### **TOWN OF MEDWAY**

## MODIFICATION ADULT RETIREMENT COMMUNITY PLANNED UNIT DEVELOPMENT (ARCPUD) SPECIAL PERMIT PLAN

Continuing Care Management, LLC The Willows at Medway and Whitney Place 259, 261, 261R and 263 Village Street

SUPPLEMENTAL WETLAND CROSSING AND SEWER LINING PACKAGE VILLAGE STREET, MEDWAY, MASSACHUSETTS 02053

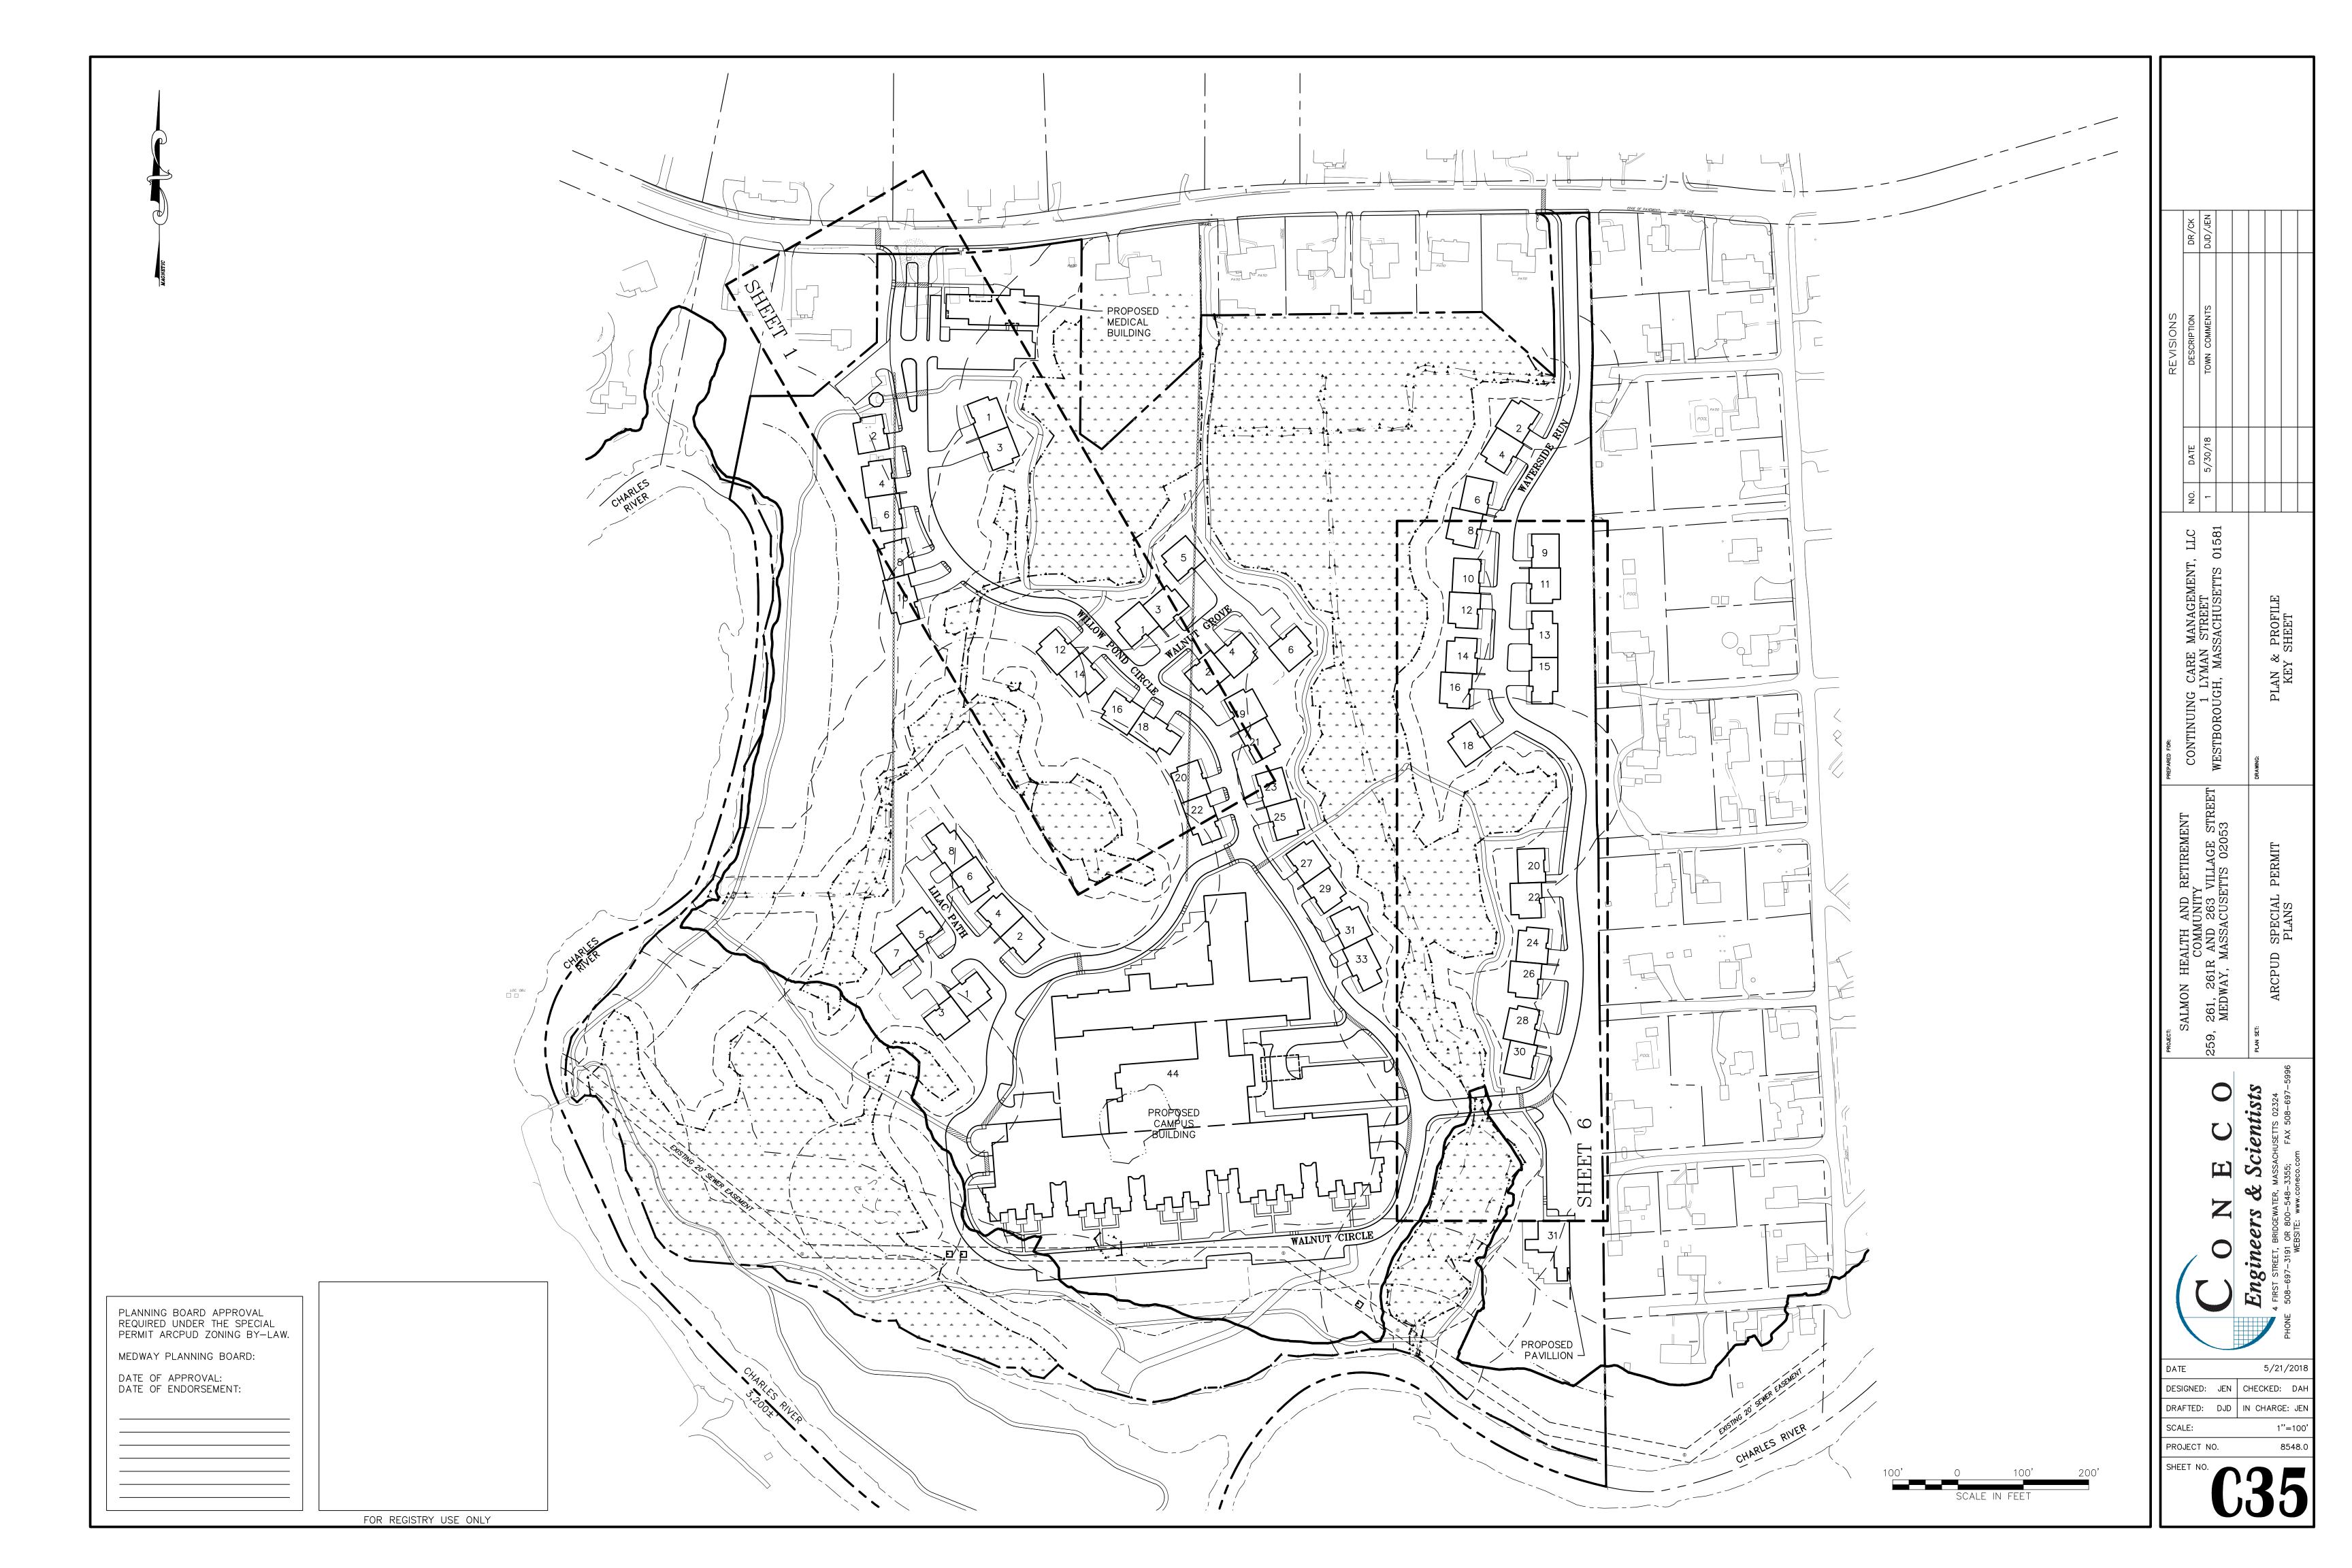
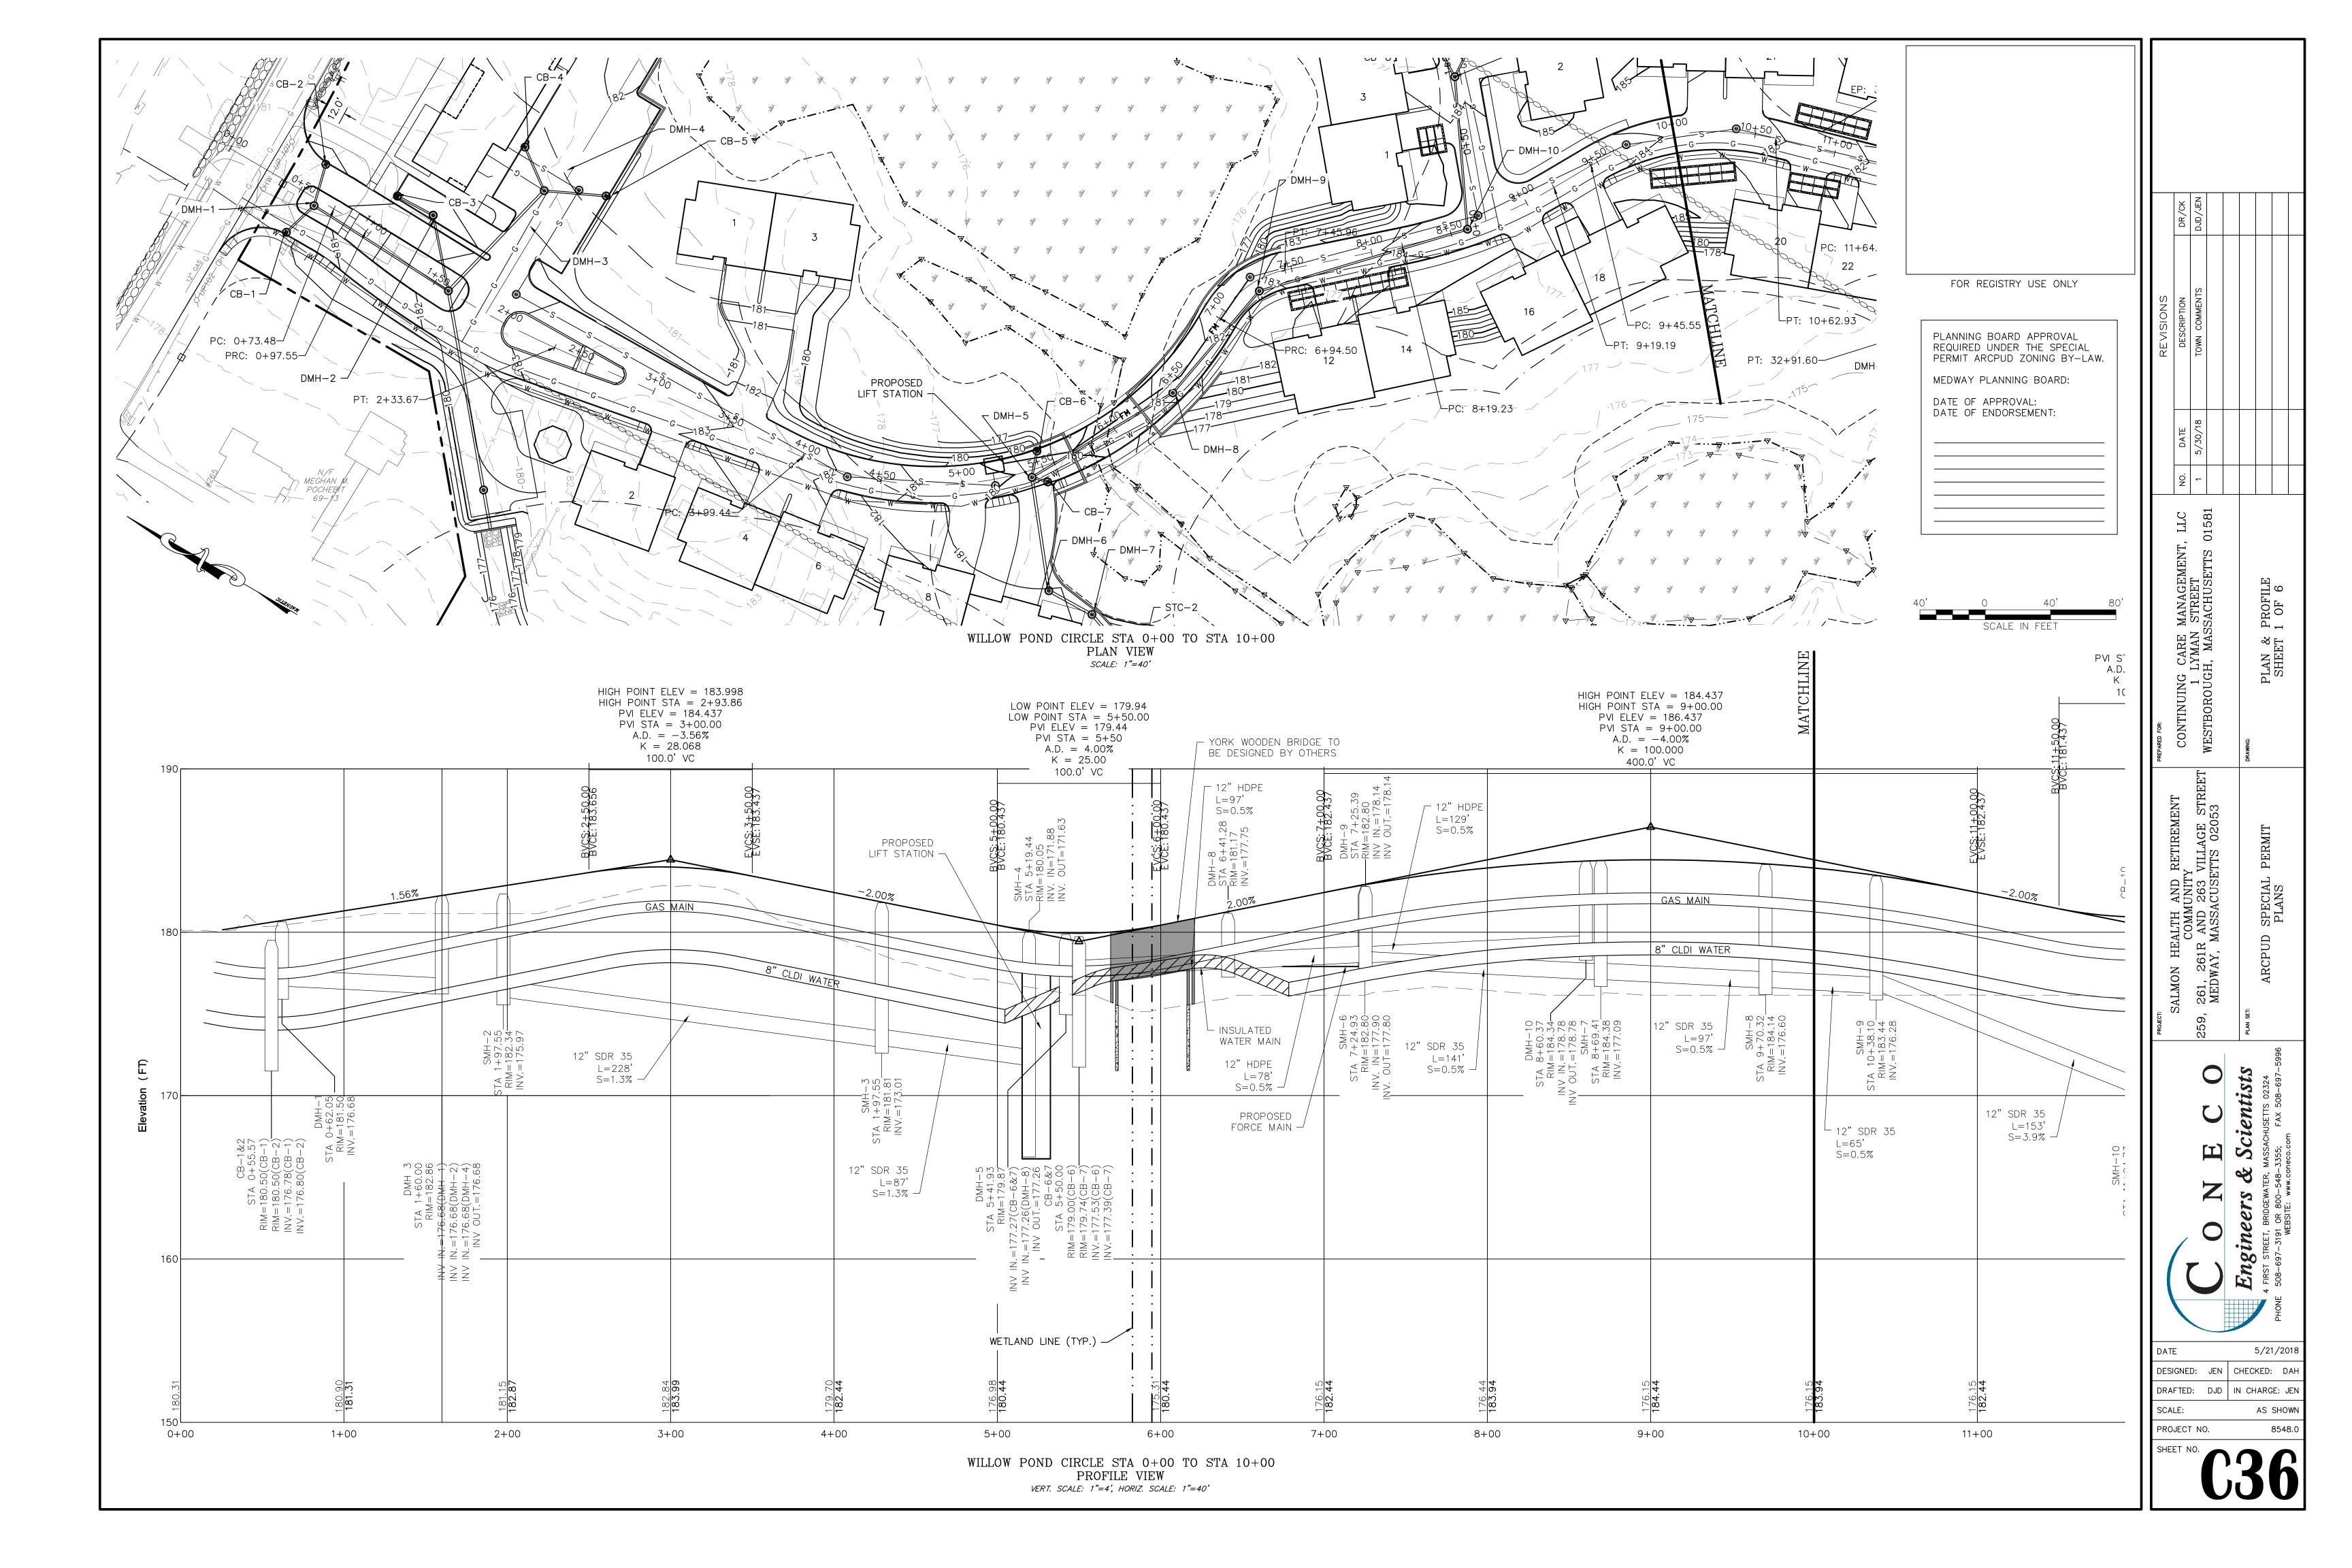
**DESCRIPTION OF PROPOSED MODIFICATION** – The proposed plan modifications were represented on the plan *Supplemental Wetland Crossing and Sewer Lining Package*, prepared by Coneco Engineers and Scientists of Bridgewater, MA, dated May 21, 2018 (Cover Sheet plus Sheets C1, C35, C36, C41, C42, C43, S1 & S2). The plan revisions reflect changes developed during the preparation of construction drawings and pertain to the following:

- Changing the structures for the two wetlands crossings from the previously approved precast concrete culvert crossings to wooden bridges. These bridges will be less intrusive on the wetlands because the abutments use driven piles. The wood alternative is a more attractive option and will enhance the overall aesthetic of the development. This bridge option should also be able to eliminate the shoring/sheeting associated with the previously approved culvert structures and bring the stream crossing design closer to the optimum design guidelines of the "Massachusetts River and Stream Crossing Standards."
- Adding three manholes to access the Charles River Pollution Control District (CRPCD) main sewer trunk line which crosses the Salmon property in order to access the pipe to make needed repairs, as may be required by the CRPCD.

- 1. THE PLANS CONTAINED IN THIS SET ARE INTENDED TO REPLACE SHEETS C35, C36, C41, C42, AND C43 OF THE PREVIOUSLY APPROVED "ARCPUD SPECIAL PERMIT PLANS" BY CONECO ENGINEERS AND SCIENTISTS, INC. LAST REVISED MAY 23, 2016. THESE SHEETS ARE BEING REPLACED PER THE MODIFICATION TO THE PREVIOUSLY APPROVED WETLAND CROSSING.
- ALL NOTES AND SPECIFICATIONS STATED IN THE "ARCPUD SPECIAL PERMIT PLANS" BY CONECO ENGINEERS AND SCIENTISTS, INC. LAST REVISED MAY 23, 2016 APPLY TO THIS SET.
- ALL WORK SHOWN IN THIS PLAN SET IS WITHIN THE PREVIOUSLY APPROVED LIMIT OF WORK. NO ADDITIONAL WETLAND OR BUFFER IMPACTS ARE PROPOSED IN THIS PLAN SET.
- 4. WETLAND CROSSINGS TO BE IN AESTHETIC STYLING OF POINTE WEST BRIDGE IN VERO BEACH, FLORIDA OR APPROVED EQUAL. (SEE YORK BRIDGE CONCEPTS, INC. IMAGE ON BOTTOM RIGHT OF THIS SHEET).

The plan was reviewed by Tetra Tech, the Town's Consulting Engineer. There were no issues with the proposed bridge changes as they do not increase disturbance compared to the previously approved crossings; the land disturbance is actually less overall. Upon review of the proposed modification, the Planning and Economic Development Board determined that the proposed changes will not be detrimental to the achievement of the planned senior living community as originally approved.
